SERVICE BULLETIN

Beech**ATA CODE 11-30****TITLE: PLACARDS AND MARKINGS - INSTALLATION OF FUEL SELECTOR PLACARD****SYNOPSIS OF CHANGE**

SERVICE BULLETIN

TITLE: NAVIGATION - YEAR 2000 SOFTWARE ANOMALY

Figure 1

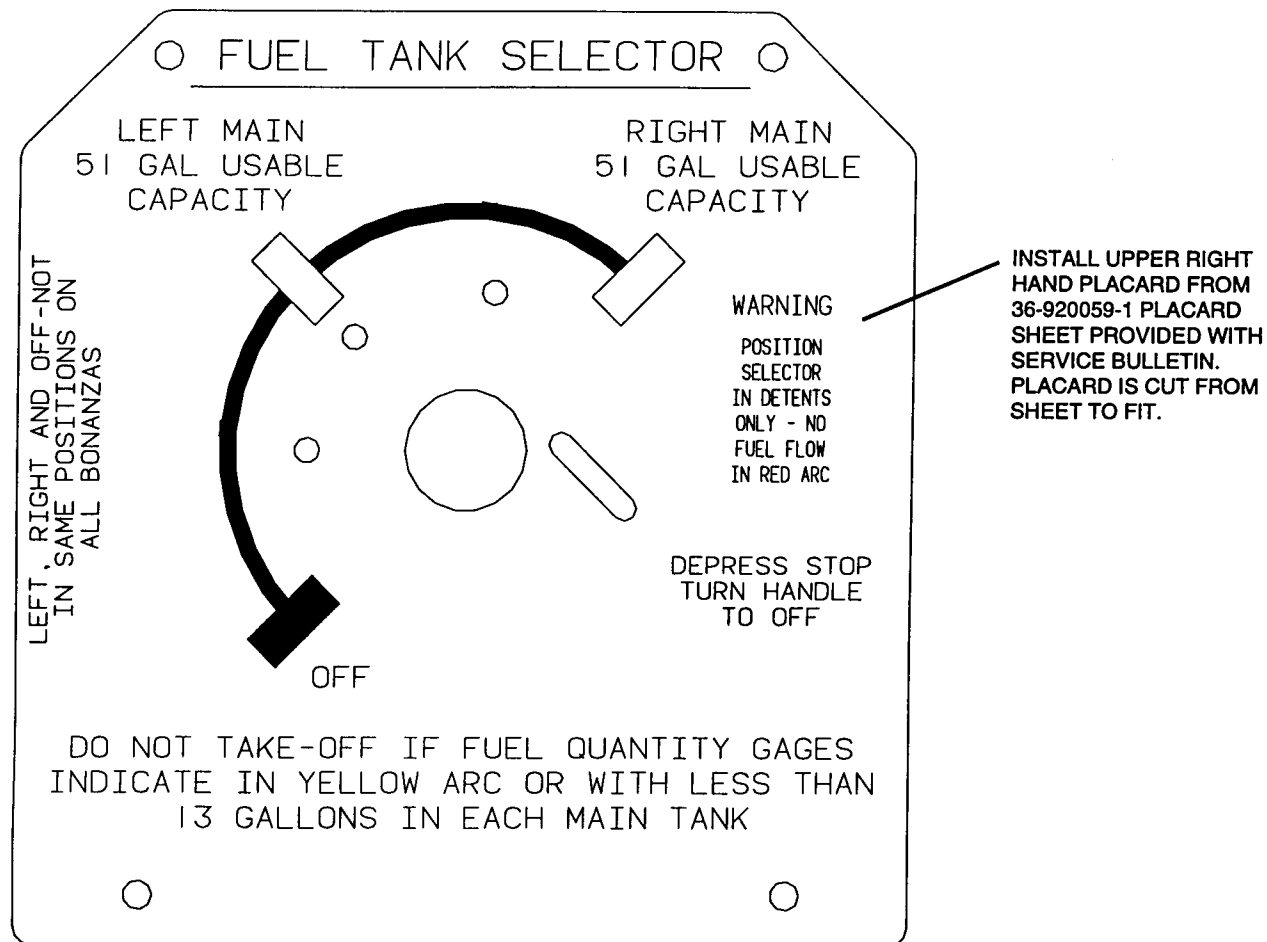
- (1) Figures 1 and 2 (and matching placards attached) are to be used primarily for the serials shown but may be used as an example of suitable configurations for typical Beech single-engine and twin-engine Beech airplanes. The no-flow sectors include the areas between tank detents and any "OFF" selection. Ensure that the placard does not cover any existing words or markings.

- (3) The placards on the bottom of the sheet with "ENGINES" in plural, are to be used for twin engine airplanes only. The rest should be used on single engine airplanes. Cut the appropriate placard from the sheet and trim to fit on available space of the fuel selector valve. Do not remove the paper from the backside of the placard until the placard is ready to be installed.

- (4) Dampen a soft cloth sparingly with solvent, and clean the face of the fuel selector valve.
- (5) Remove paper from adhesive side of the placard and affix to face of fuel selector valve.
- (6) Ensure all work areas are clean and clear of tools and miscellaneous items of equipment.
- (7) Insert Figure 3 at the end of your AFM, if applicable. If your airplane has a POH or POM, you will receive a Temporary Revision or Supplement.
- (8) Return airplane to service.

FUEL SELECTOR VALVE
(B36TC SHOWN, A36TC SIMILAR)

EFF: A36TC SERIAL EA-1 THRU EA-241 AND EA-243 THRU
EA-272 WITH BEECH KIT NO. 36-9008-1 INSTALLED,
KIT SERIAL NUMBERS 101 THRU 389 ONLY. B36TC
SERIALS EA-242 AND EA-273 THRU EA-591.

Figure 2

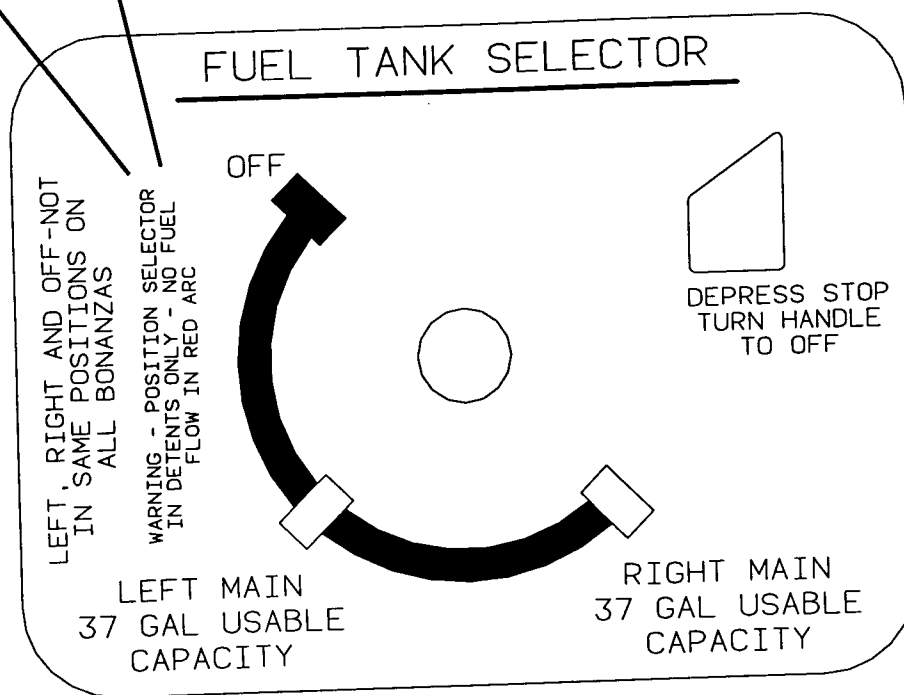
PLACARD IS
CUT FROM
SHEET TO FIT

INSTALL UPPER LEFT HAND
PLACARD FROM 36-920059-1
PLACARD SHEET PROVIDED
WITH SERVICE BULLETIN

FUEL TANK SELECTOR COVER

EFF: F33A - CE-1014 THRU CE-1791
F33C - CJ-156 THRU CJ-179
A36 - E-2062 THRU E-3046
